**AGENDA**  
**DANIA BEACH CITY COMMISSION**  
**REGULAR MEETING**  
**TUESDAY, OCTOBER 25, 2016 - 7:00 PM**

A RESOLUTION OF THE CITY COMMISSION OF THE CITY OF DANIA BEACH, FLORIDA, APPROVING THE SITE PLAN (SP-75-15), DESIGN VARIATIONS (OT-64-16/OT-82-16) AND VARIANCE (VA-98-16) SUBMITTED BY DAVID L. WALLACE & ASSOCIATES, INC. ON BEHALF OF THE OWNER, ALEXEY SHCHETNIKOV, FOR PROPERTY LOCATED AT 321 NORTH FEDERAL HIGHWAY IN THE CITY OF DANIA BEACH, FLORIDA; PROVIDING FOR CONFLICTS; FURTHER, PROVIDING FOR AN EFFECTIVE DATE. *(Continued from August 23, 2016 and October 10, 2016)*

2 WEST ELEVATION  
A-200  
SCALE 3/32" = 1'-0"

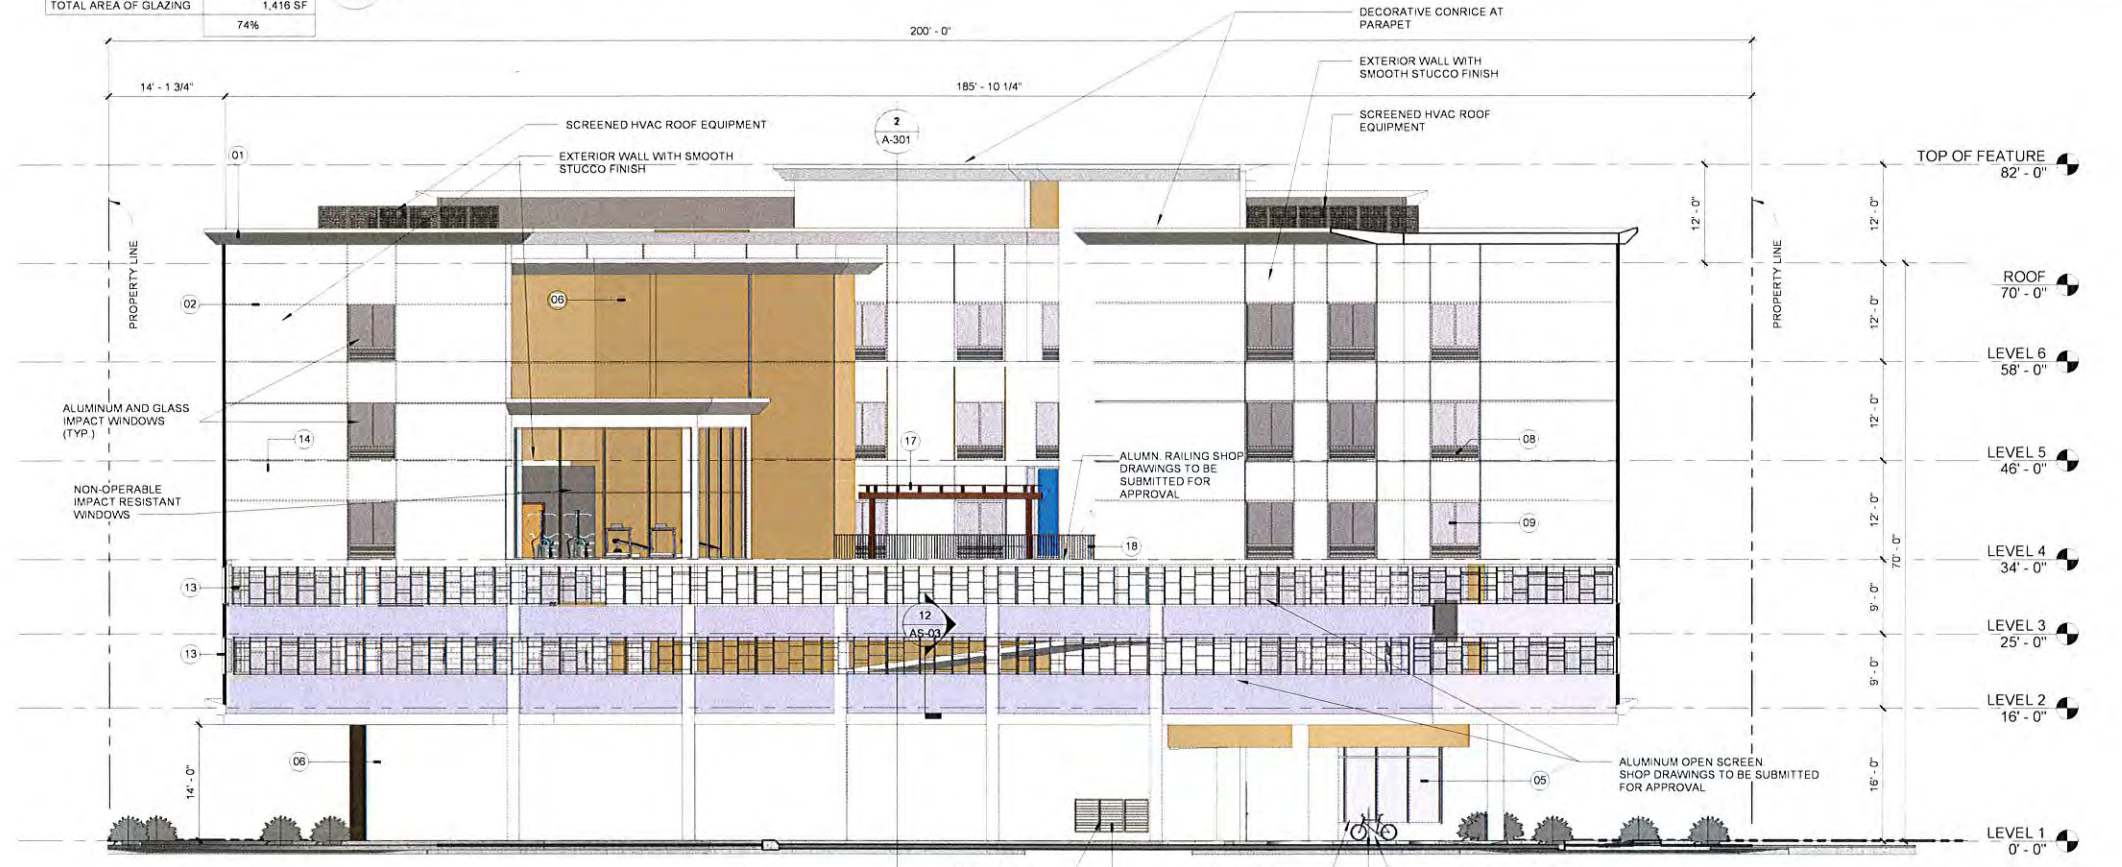
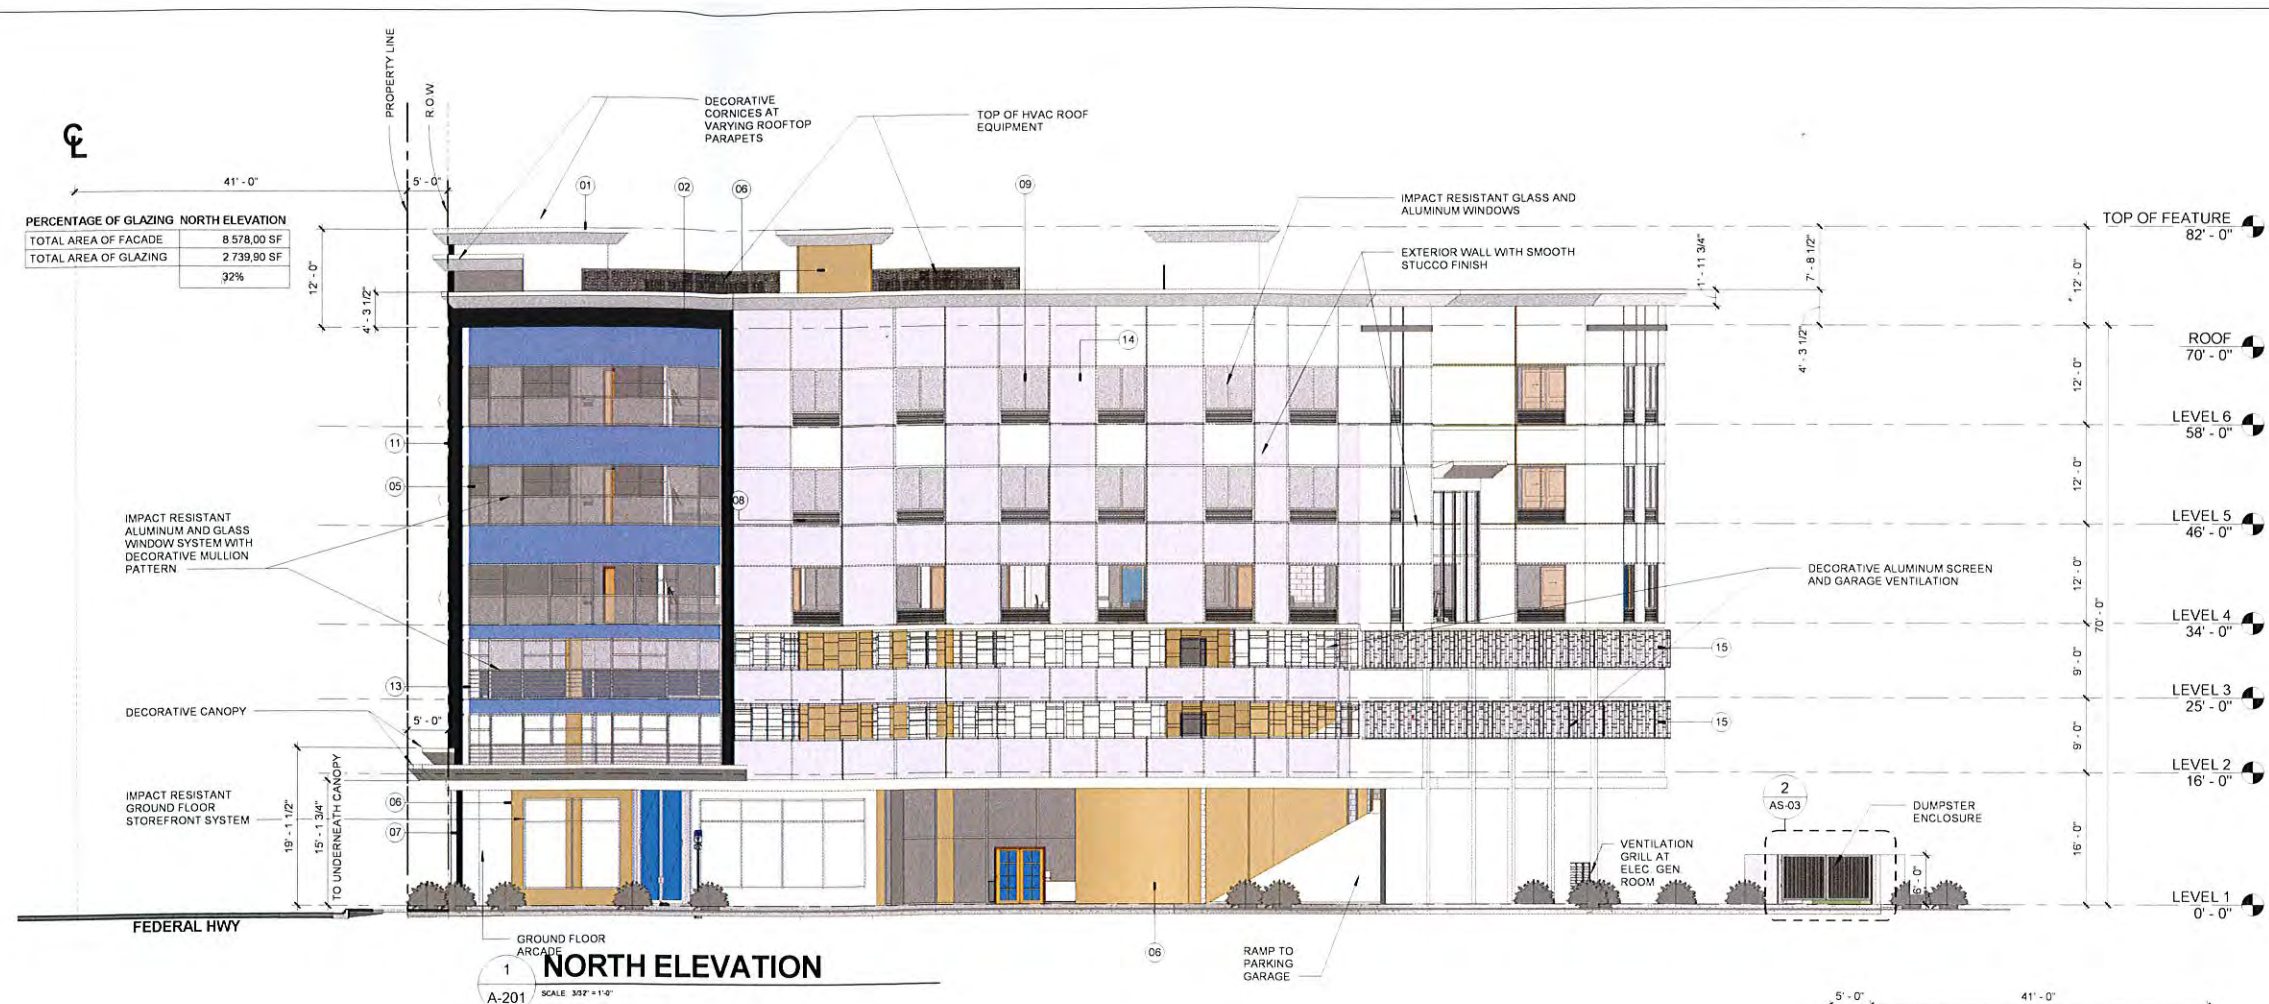
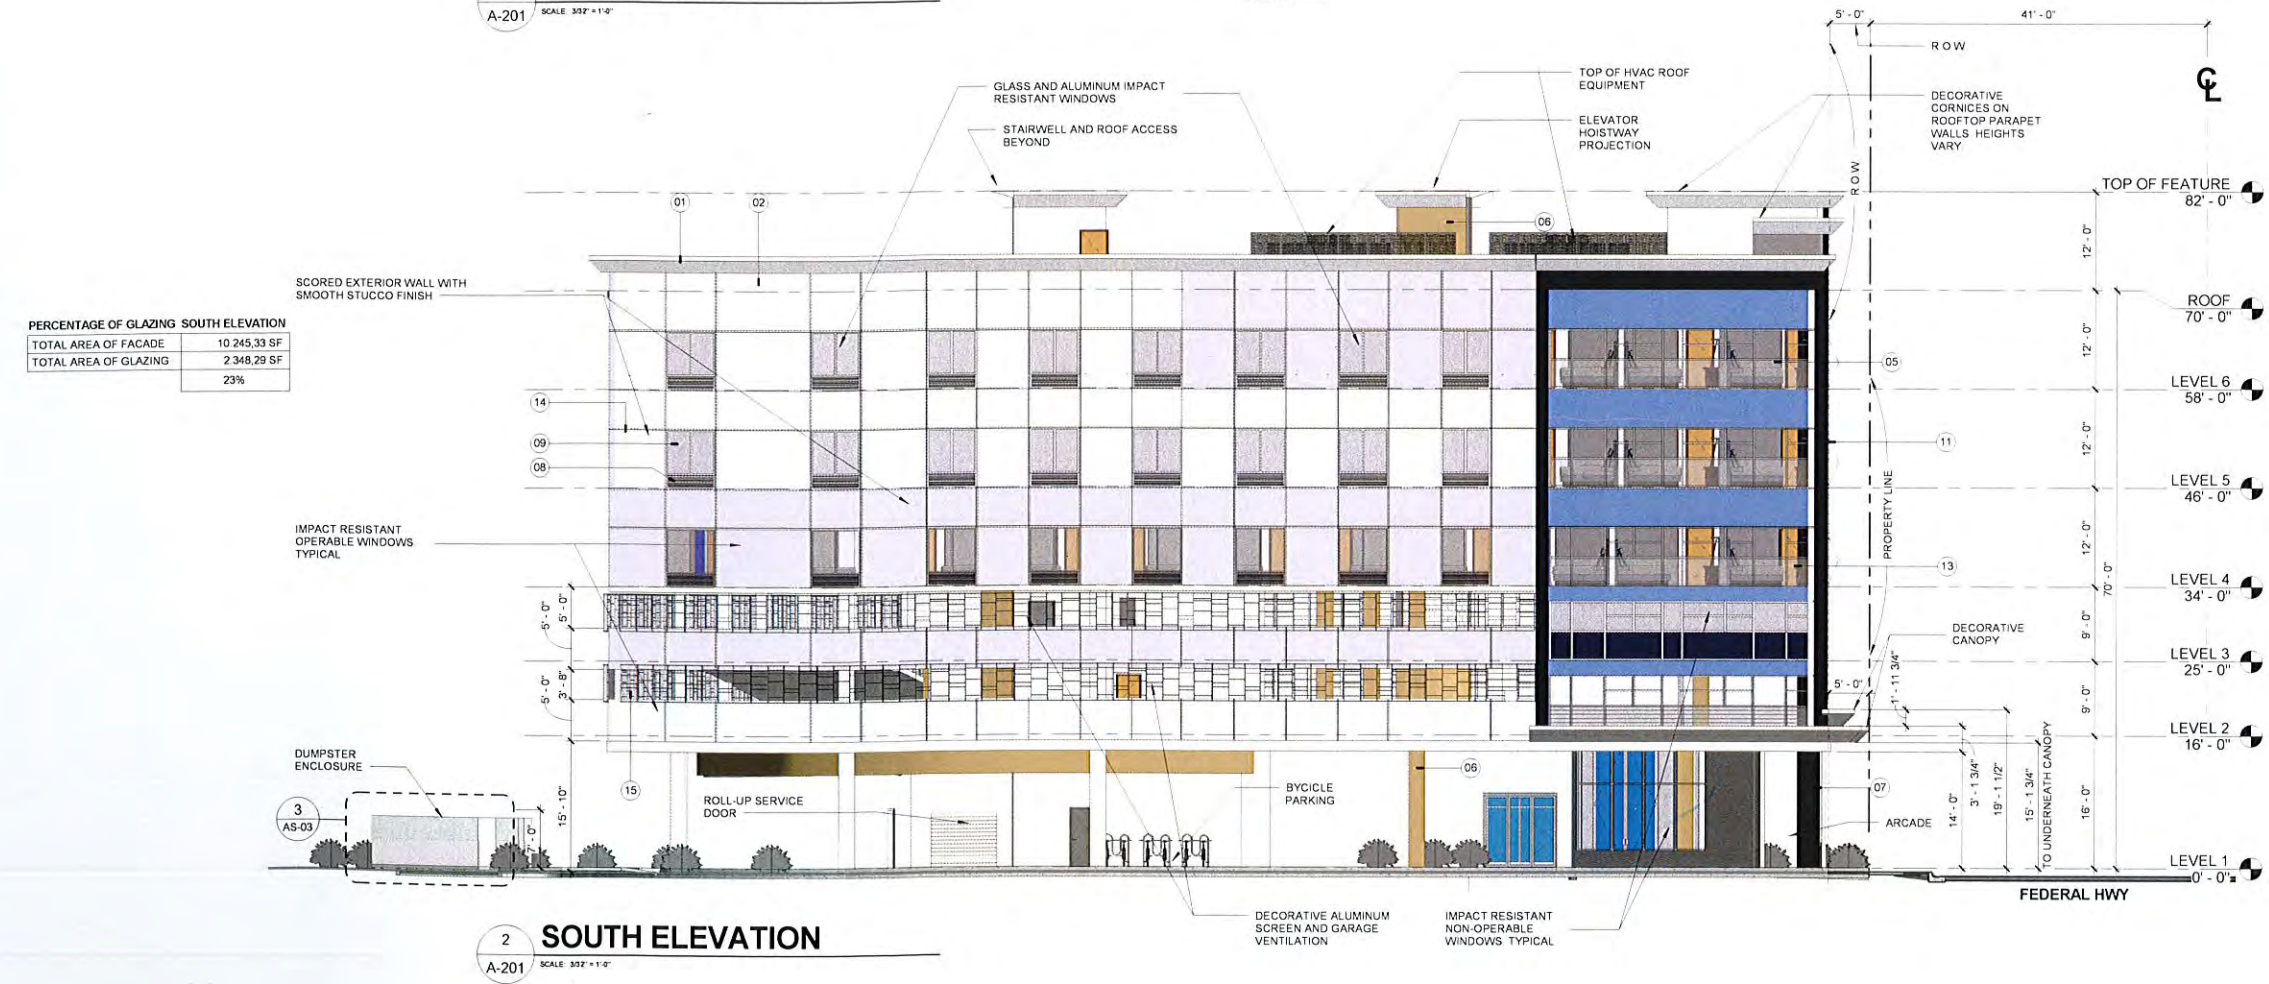
Identify how equipment will be screened from view. In addition, rooftop a/c must be located on flat roof and on the rear ½ of building. Identify compliance on plans. 2nd time requested (Planning). Sheet A-200 appears to indicate that the rooftop mechanical equipment will be visible. Revise accordingly.

**Sheet A-200 appears to indicate that the rooftop mechanical equipment will be visible.**

38. Per Section 525-20(G) all rooftop mechanical equipment/stairs/elevator shall be designed to be an integral part of the building or shall be adequately screened and shall not exceed 12' in vertical height and not to exceed 20% of roof top. Identify how this provision is being met on the plans. 2nd time requested. Sheet A-200 & A-201 appear to show HVAC roof equipment visible from all elevations. Revise according.

**RESPONSE:** REFER TO ROOF PLAN INDICATING LOCATION OF AC EQUIPMENT ON FLAT ROOF ALONG WITH THE VARYING HEIGHTS OF THE ROOF PARAPET WHICH ALSO SERVE TO PROVIDE SCREENING OF THE EQUIPMENT FROM VISIBILITY. THE ROOFTOP EQUIPMENT IS LOCATED TOWARDS THE INTERIOR OF THE ROOF SPACE AWAY FROM THE BUILDING EXTERIOR AND THEREFORE WOULD NOT BE VISIBLE FROM THE EXTERIOR DUE TO THE SURROUNDING PARAPET WALLS AND VANTAGE POINT NEEDED. SHEET A-201 IS AN ORTHOGONAL ELEVATION VIEW AND NOT REPRESENTATIVE OF HOW IT WOULD BE SEEN IN PERSPECTIVE.

**RESPONSE:** SHOPFRONT COMPLIES WITH 70% GLASS MINIMUM AT GROUND FLOOR AND INCLUDES A REVISED RECESSED ENTRY WITHIN AN ARCADE LINING PARALLEL TO NORTH FEDERAL HIGHWAY. REFER TO EAST ELEVATION SHEET A-200 INDICATING HEIGHTS, DIMENSIONS AND CALCULATIONS.

1 BUILDING SECTION 2  
A-301 1/8" = 1'-0"

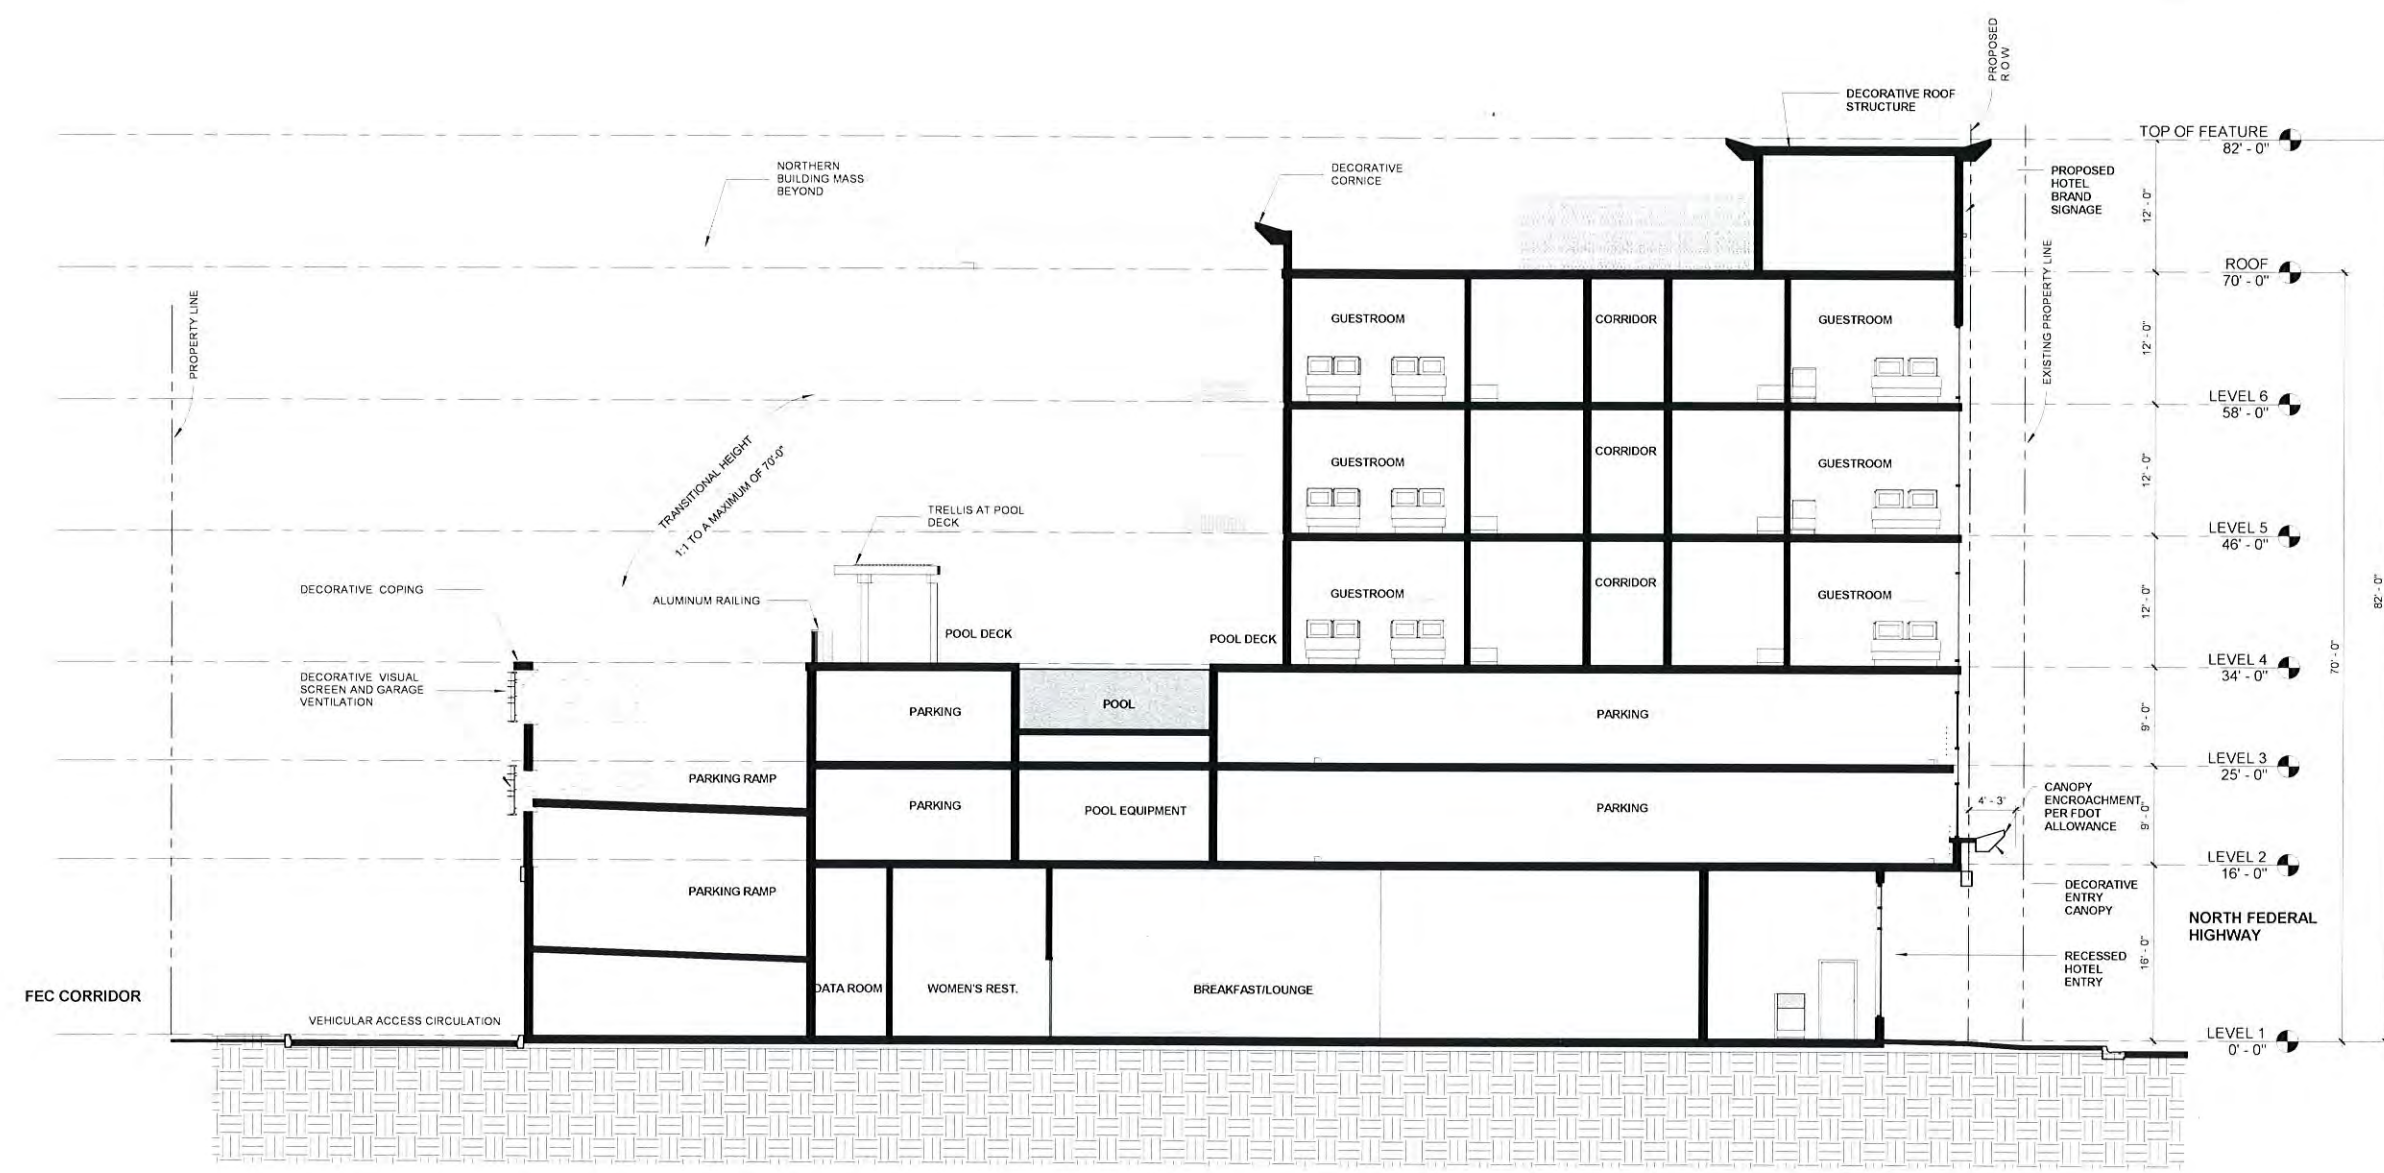
37. Per Section 303-40(Q), Figure 303-10 & 304-30 allowable height is based on proximity to residential and FEC railroad. Provide illustration showing building mass is outside of the 1.66:1 slope. Provide illustration with next submittal. Revise to reflect property slope. 2nd time requested (Planning).

**RESPONSE:** REFER TO SECTION DRAWING 1/A-301 AND AR-102 ILLUSTRATING BUILDING MASS REFLECTING THE DISCUSSIONS IN THE INITIAL ROUNDTABLE DISCUSSIONS MEETINGS WITH MARC LAFERRIER. APPROXIMATELY 1/3 OF THE BUILDING MASS COMPLIES WHILE THE REMAINING BALANCE SERVES TO FORM THE EXTERIOR COURTYARD WHOSE ARRANGEMENT AND PURPOSE IS TO REDUCE THE VISIBILITY AND EXPOSURE OF THE FEC CORRIDOR.
